ADDENDUM II

SUBJECT: Barbara Drive Drainage Phase 3 LF (2022 Bond), (WBS: 23-03927), Scheduled to Close: September 4, 2026; Date of Issue: July 31, 2026

THIS NOTICE SHALL SERVE AS ADDENDUM NO. II – TO THE ABOVE REFERENCED INVITATION FOR BID

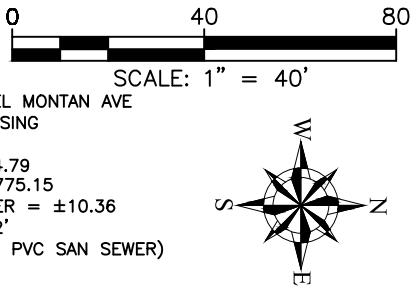
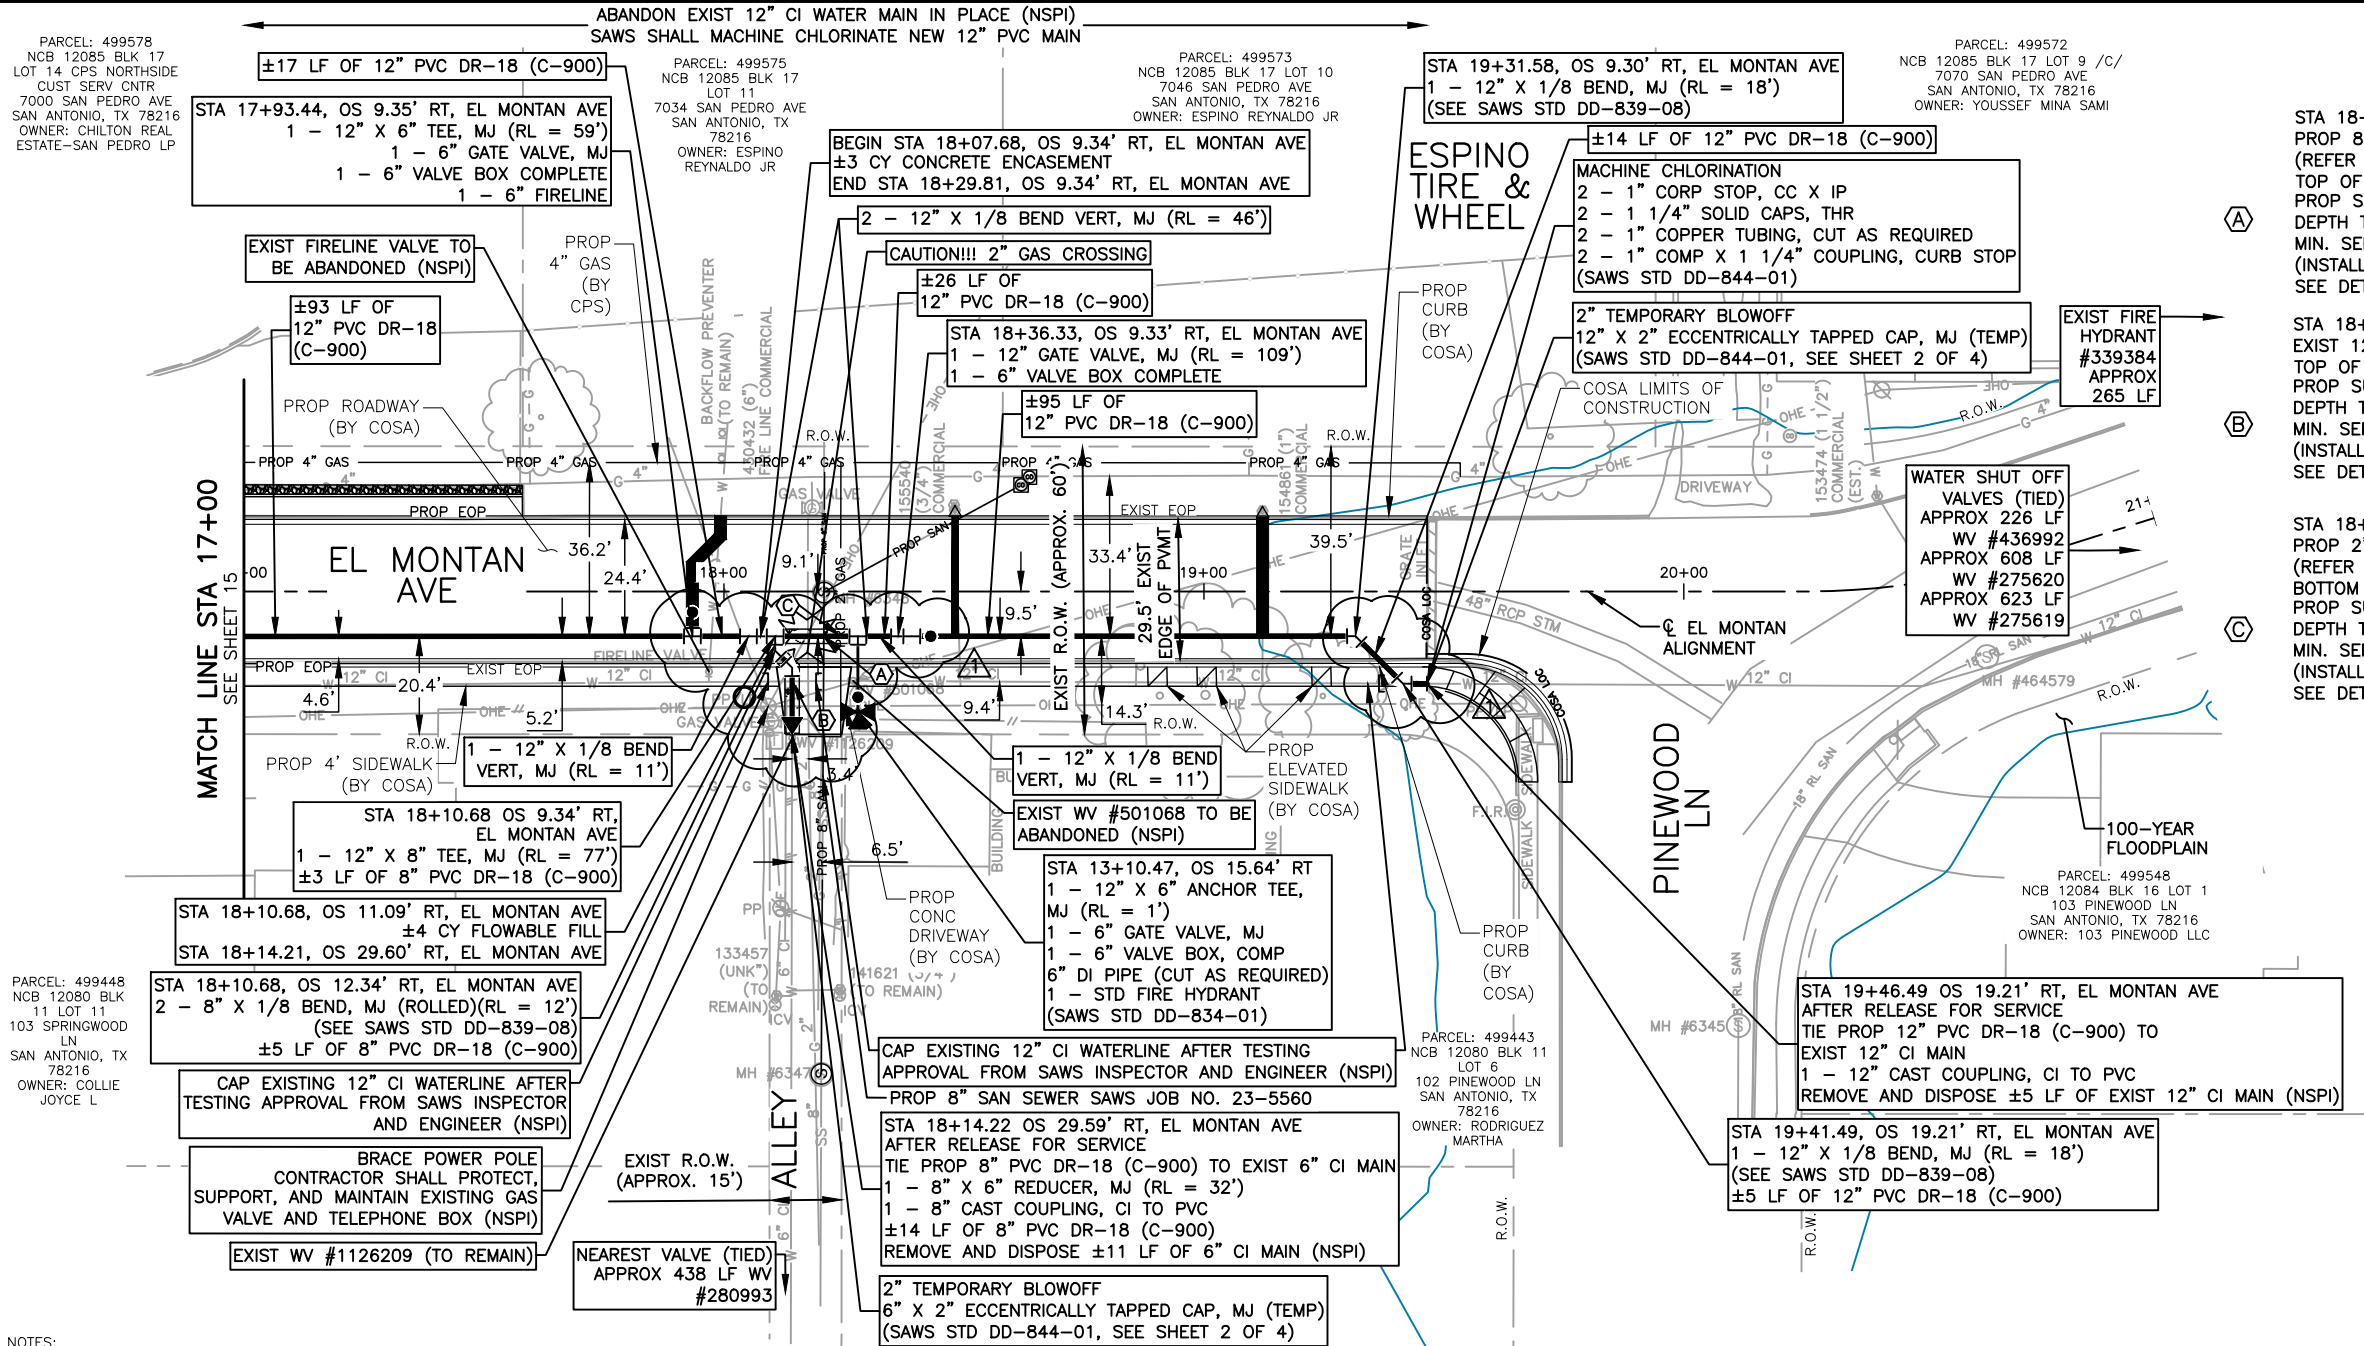
Question 24: On the saws water sheets on all of El Montan, sht 13 at Shadywood and the Alley, sht 14 at Beechwood, Alley and Maplewood, sht 15 at alley and Springwood and sht 16 at Alley there are notes concerning new main, tie-ins, bends, blow offs, Tees and gate valves but the items are not on the drawing. There are other areas as on sht 13 at sta 6+80 which calls for a FH and nothing is drawn showing the FH. Same with sta 7+93 to +/- 8+15 a vert adjustment with four bends is called out at the alley but no bends are drawn. Can these areas be revised to show the items being called out? Or, if these items are not to be part of the project, can these items notes be eliminated?

Response: See revised water sheets 13, 14, 15, and 16 that include the drawn 8" PVC Waterlines for clarity.

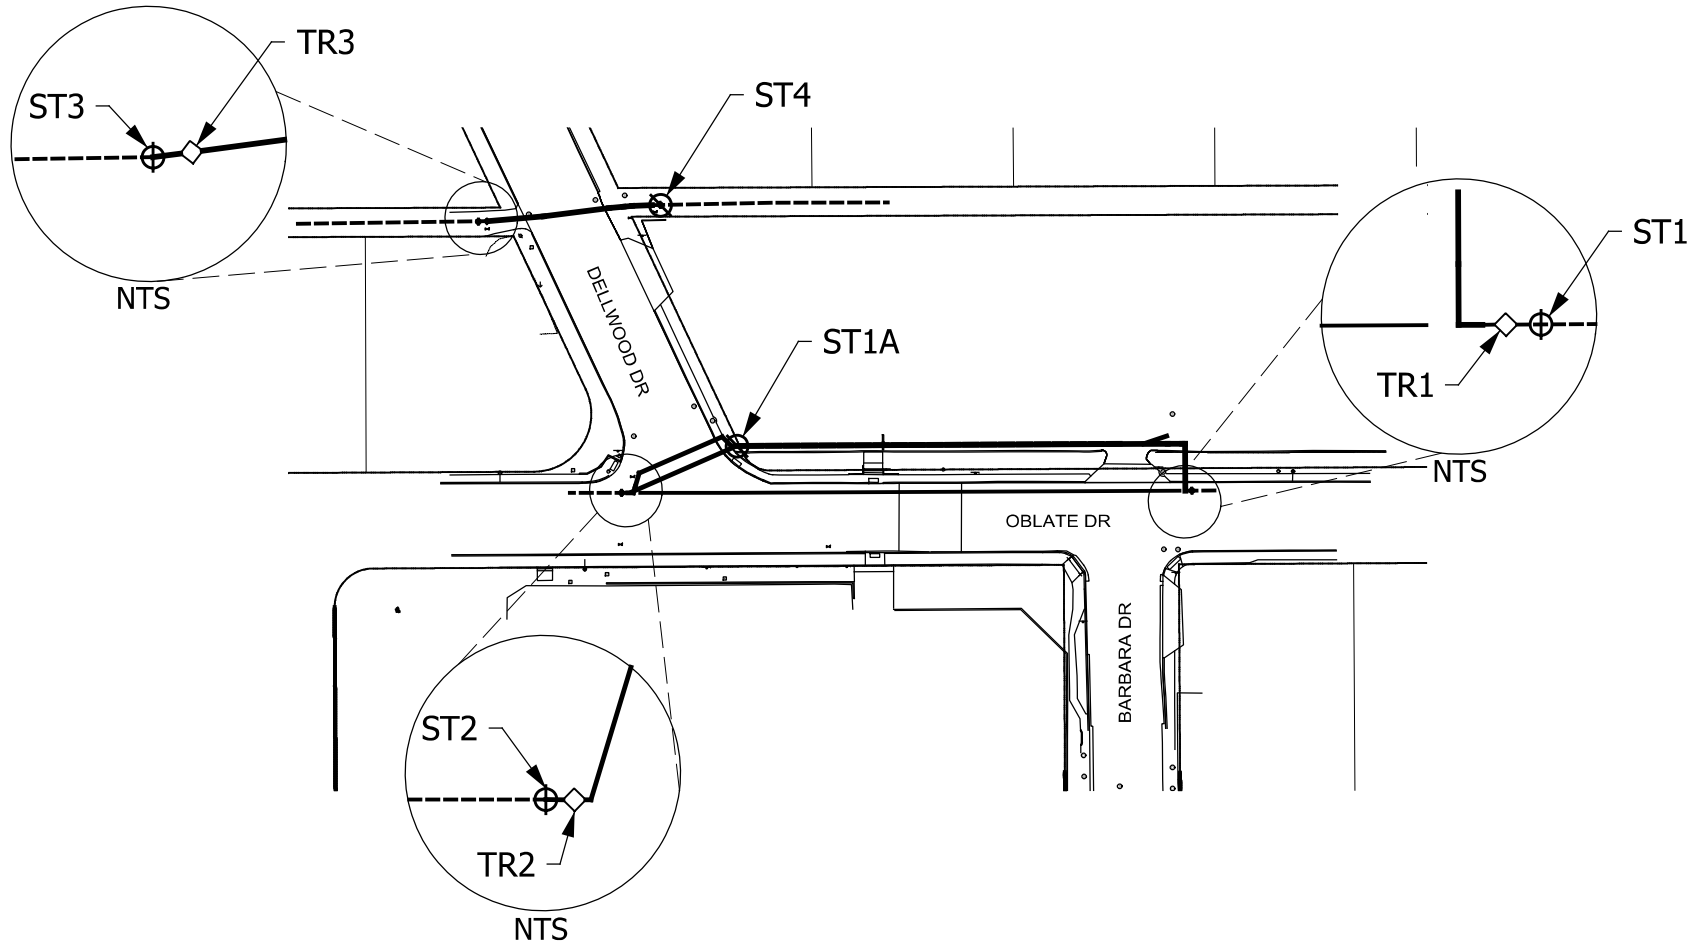
- Response: Unit pricing updated to include 2" and 4" bore items.
- Question 6: In regards to the existing 16" CPSE gas pipe, please provide information for the following: 1) Pipe Grade. 2) Pipe Wall. 3) Design Code. 4) Design Factor. 5) MAOP/MOP. 6) Operating Pressure. 7) Flow Rate expected at time of tie in. 8) Min and Max Temperature. 9) Is there any circumstance where CPS will require a double stopple bypass on the 16" main or will this work be expected to be completed when temperatures are above the constraint limit?

- Response: Pipe Specs listed on Pg 2 of 18: 16.00" O.D. x 0.312" W.T., X-42 min, F.B.E Coating, MAOP 274 PSIG. Tie-in of the 16" line should be completed when temperatures are greater than 65 degrees.

* PHASE 2 TIE-IN SHALL BE COMPLETED WHEN AMBIENT AIR TEMP IS 65° F OR ABOVE AND IS EXPECTED TO REMAIN ABOVE 65° F FOR THE DURATION OF THE OPERATION.
